Charlotte Historic District Commission Application for a Certificate of Appropriateness

HDC 2019-00175
 PID# 12305703

PROPERTY ADDRESS: 609 Berkeley Avenue

SUMMARY OF REQUEST: Garage/Accessory Dwelling Unit + Tree Removal

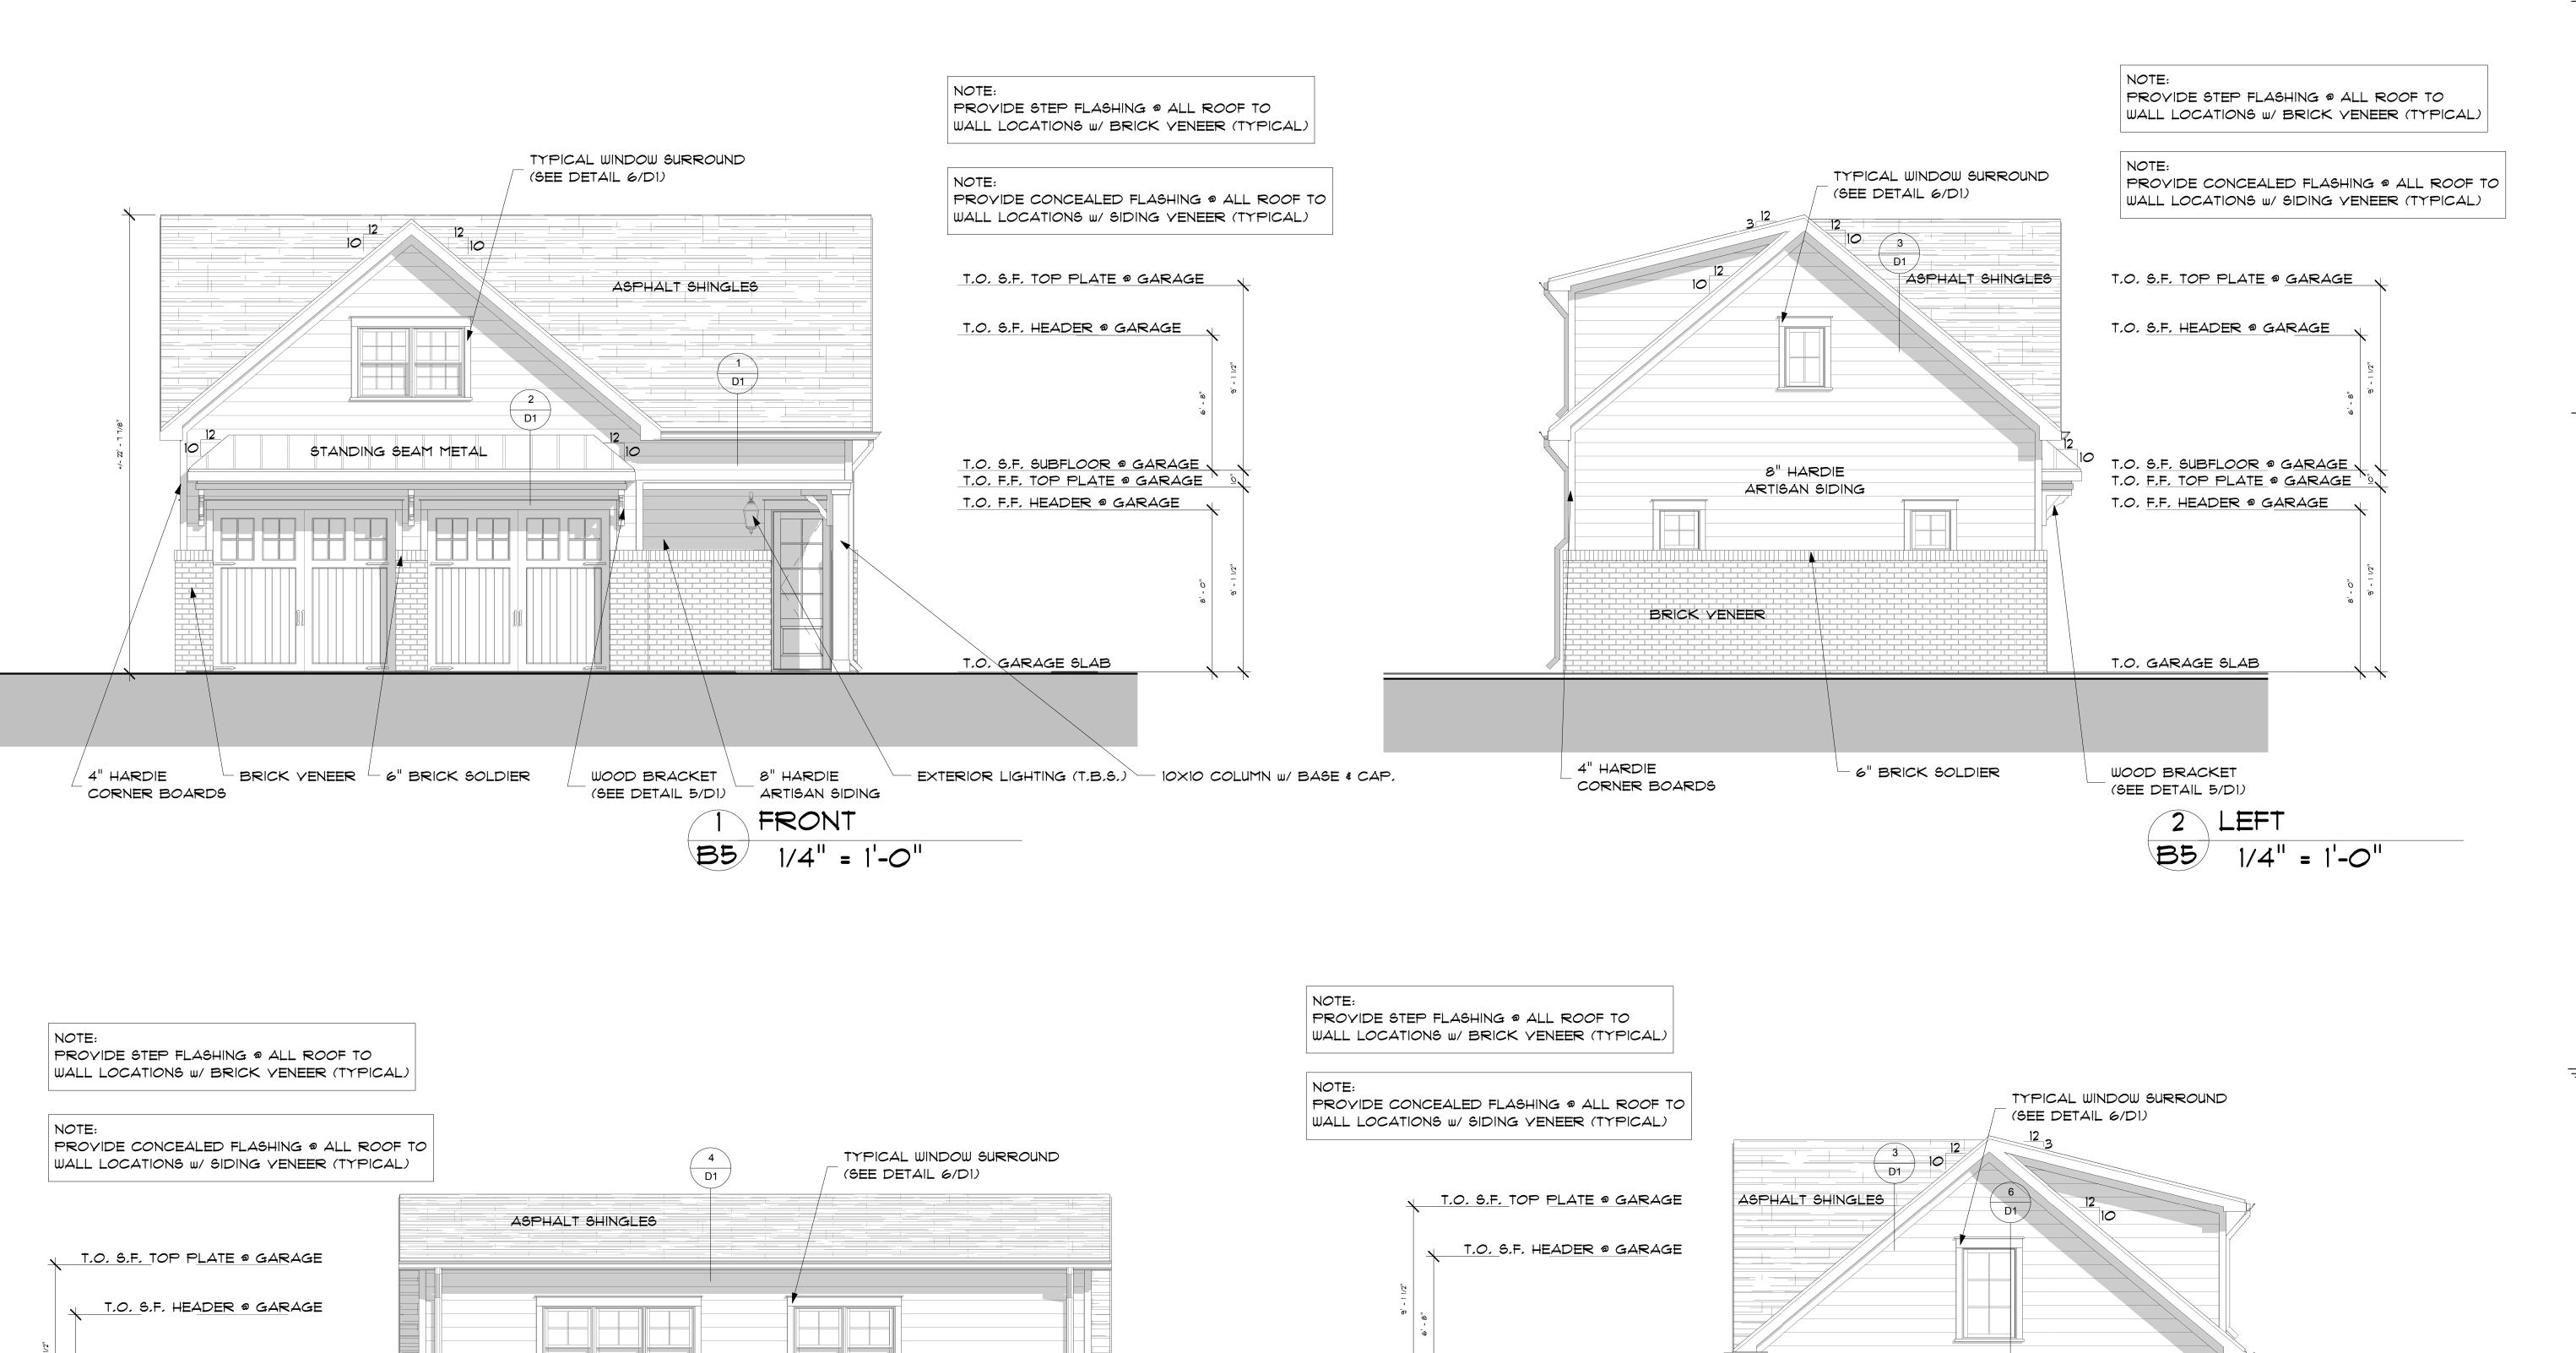
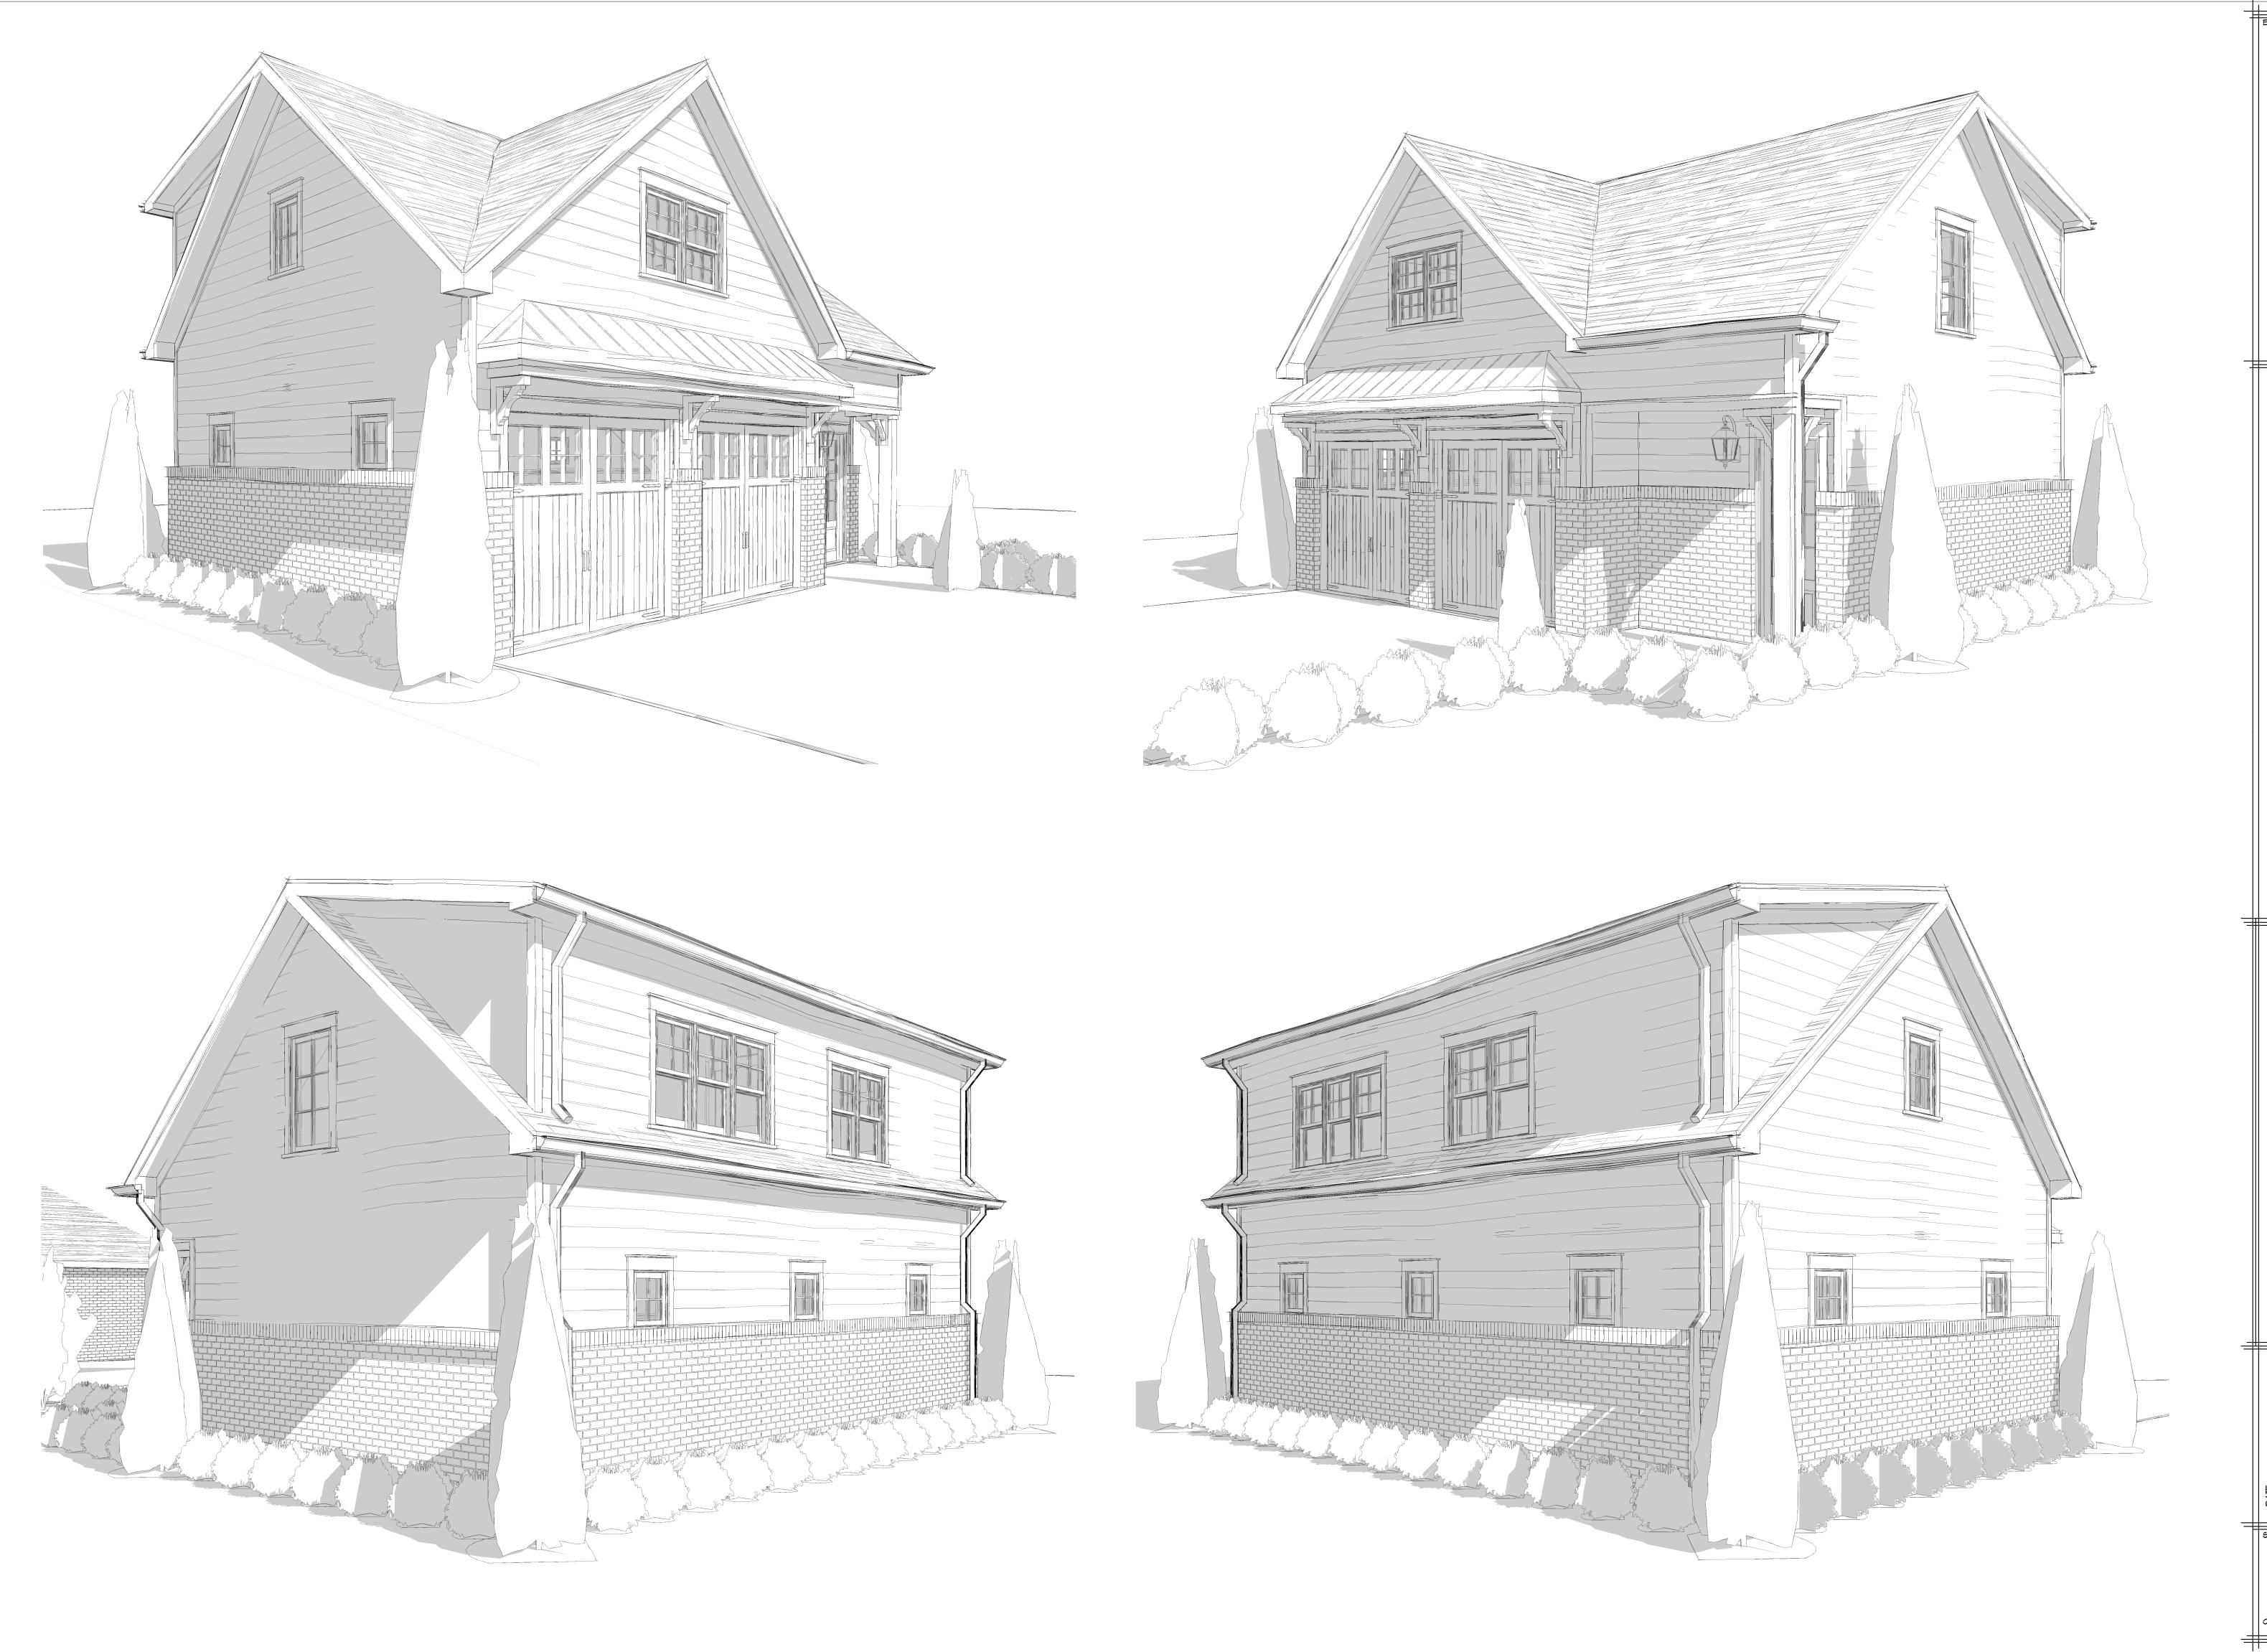
- 1. Height and massing; total height measured from grade-to-ridge not provided on B5.
- 2. Material notes missing (garage doors, column, windows, trim, etc.)
- 3. The boxed eave detail is not consistent with the eave details on the main house.
- 4. Coplanar rear dormer.
- 5. Inconsistent window patterns.
- 6. As drawn, the ADU does not meet Zoning setback requirements.
- 7. Garage footprint and width appear secondary to main structure.
- 8. Minor revisions may be reviewed by staff (including confirmation that setbacks meet zoning requirements, materials, eave details, window patterns, etc.).
